PLANNING COMMISSION REPORT
Regular Agenda -Public Hearing Item

PC Staff Report
9/26/2016

ITEM NO. 8B: PDP-16-00311; HERE @ KANSAS OFF-SITE PARKING PRELIMINARY DEVELOPMENT PLAN (SLD)

PDP-16-00311: Consider a Preliminary Development Plan to accommodate the construction of an *Accessory Parking* lot for HERE @ Kansas, located off site at 1029 Mississippi, 1031 Mississippi, and 0 Illinois St. Submitted by Landplan Engineering PA on behalf of 1029 Mississippi LLC, STADPKG LLC, property owner of record.

Figure 2: New Access Easement/Alley Access

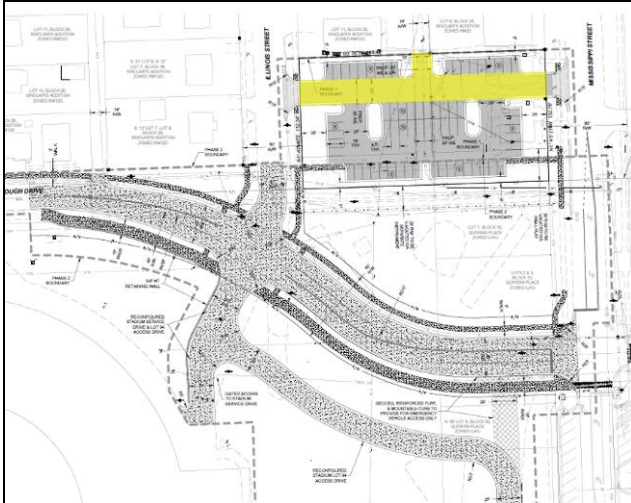
The alley, located between Mississippi and Illinois Streets, is proposed to be partially vacated. However, the alley will still be used by the public and private property owners to the north. Full access of the alley from both the north and south is required. The proposed project includes an access easement through the new parking lot to accommodate continued alley access.

The existing Fambrough Drive right-of-way will be vacated with half of the right-of-way given back to the north property owner (Endowment Association) and the south half given back to the University of Kansas (south property owner). The realigned Fambrough Drive will be a public street with University property located on both the north and south sides of the property.

Figure 3: Preliminary Plat Lot 1 & Lot 2 option

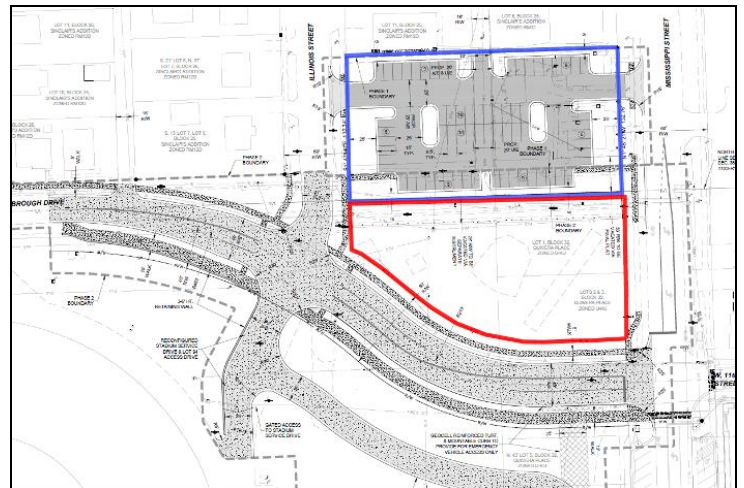
New access driveways to the University parking lot next to the stadium will also be constructed with this project. The University is considering participating in the subdivision process that may or may not create a platted lot on the north side of the realigned Fambrough Drive. They are not required to participate in the subdivision of their property. The following graphic highlights the general lot/parcel configuration that will result at the conclusion of this development process, if approved.

The proposed lot (parking lot) meets the minimum subdivision design standards for lot area, width and frontage.

New right-of-way will be dedicated for Fambrough Drive with the Final Plat for this project.

Figure 6: Landscape plan showing north side of parking lot

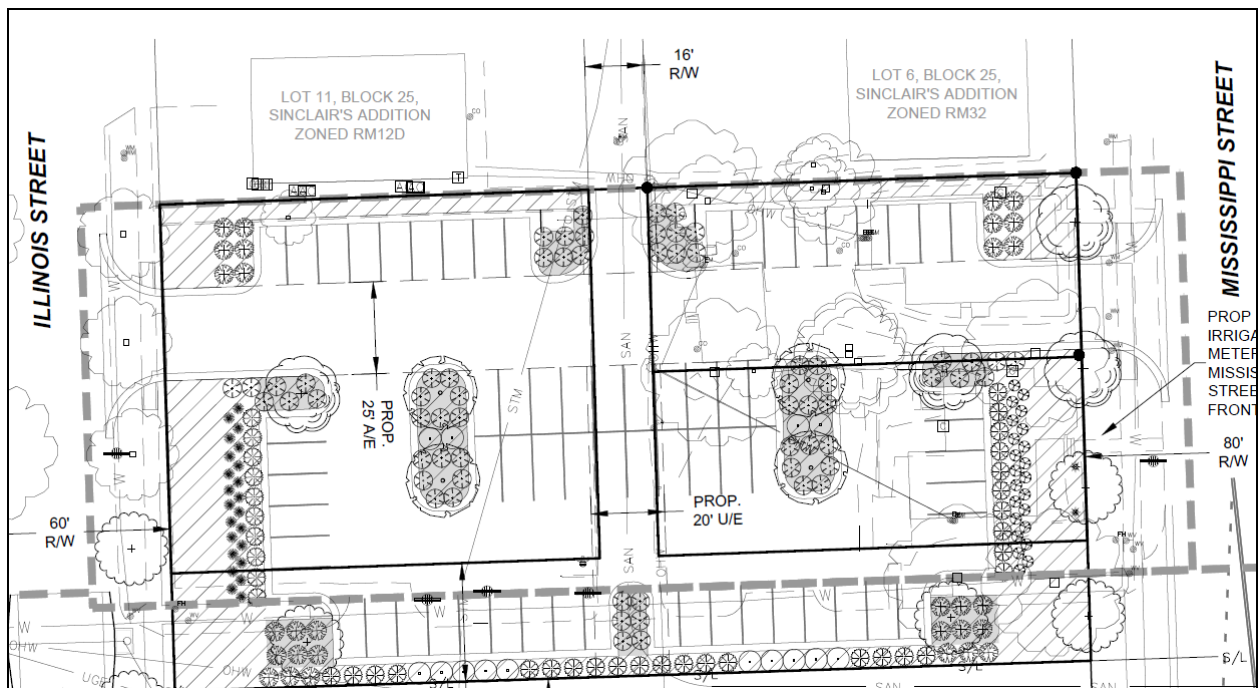
Screening and Fencing: The property owner of 1020 Illinois Street, to the north, has indicated that the existing apartments have a “view” of the University across the existing surface parking lot. The building is a two story structure with windows on the south side. It is that property owners desire to maintain visibility of the University.

First floor windows are located just above the grade. Screening of vehicle car lights is appropriate on the north side of the *Accessory Parking* lot, but conflict with the desire of 1020 Illinois owner to not block views. Screening could include low shrubs. Fencing, to establish the

boundary between the *Accessory Parking* lot and the multi-dwelling residences to the north, could include open fencing such as aluminum, wrought iron or similar fencing materials found in the surrounding area. Chain link fencing is not recommended.

The space between the *Accessory Parking* lot and the adjacent residence is narrow (5' wide). This limits the options to provide a buffer between the uses.

1. Provision of a revised plan that includes a note restricting the use of the property to an *Accessory Parking Lot* (surface parking lot) only.
2. Provision of a revised plan to include a typical section of screening wall to obstruct the view of the vehicles to be setback plus or minus 5' of the established building plane along Illinois and Mississippi Street.
 - a. The screening wall should include architectural elements as described in the body of this report.
3. Provision of revised plan to show ornamental fencing along the north property line, including a typical section, that provides basic security without blocking out the light for the tenants living in the south facing units.

Figure 9: Surrounding Zoning/Buffer Yard

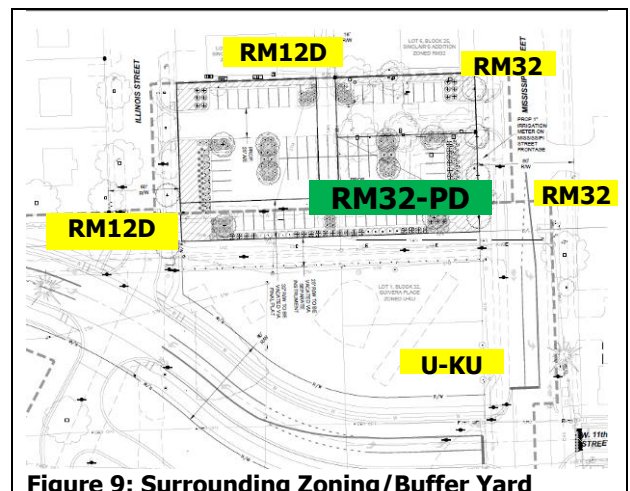
Buffer yards are required between dissimilar zoning districts. An example would be where an RM district abuts an RS district a *Type 1 Buffer Yard* is required. This property abuts RM zoning to the north, east and west. A buffer is not required between RM and RM districts. The property to the south is a special purpose district. The Development Code does not proscribe a buffer yard for areas that abut University zoned property.

A buffer yard is not required for this project.
